# UNITED STATES PATENT AND TRADEMARK OFFICE

APPLICATION NO.	FILING DATE	FIRST NAMED INVENTOR	ATTORNEY DOCKET NO.	CONFIRMATION NO.
10/779,471	02/13/2004	Bradford G. Baruh	033151-026	5526

**Office Action Summary**

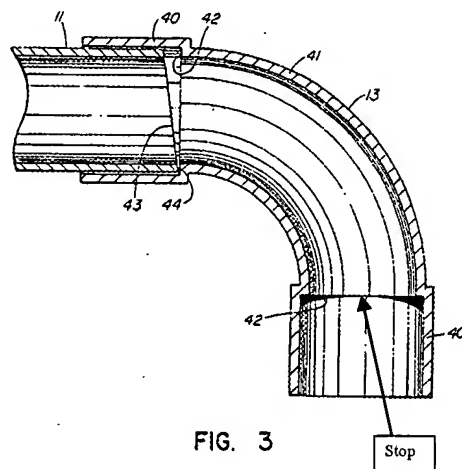
Claims 1, 4 and 11 are rejected under 35 U.S.C. 102(b) as being anticipated by US patent 4783099, Muser.

In regards to claim 1, Muser discloses a pipe coupling comprising:

an elongated housing comprising a first end and a second end, the housing defining an elongated bore therein;

a stop (see Figure 3 below) located on an inner diameter of the housing, the stop located between the first end and the second ends of the housing, wherein a distance from the stop to one of the first and second ends is at least two times a distance from the stop to the other of the first and second end of the housing;

a first cylindrical bore extending from the first end to the stop; and

a second cylindrical bore extending from the second end to the stop, wherein an angle between the first cylindrical bore and the second cylindrical bore is about 15 degrees to about 165 degrees.
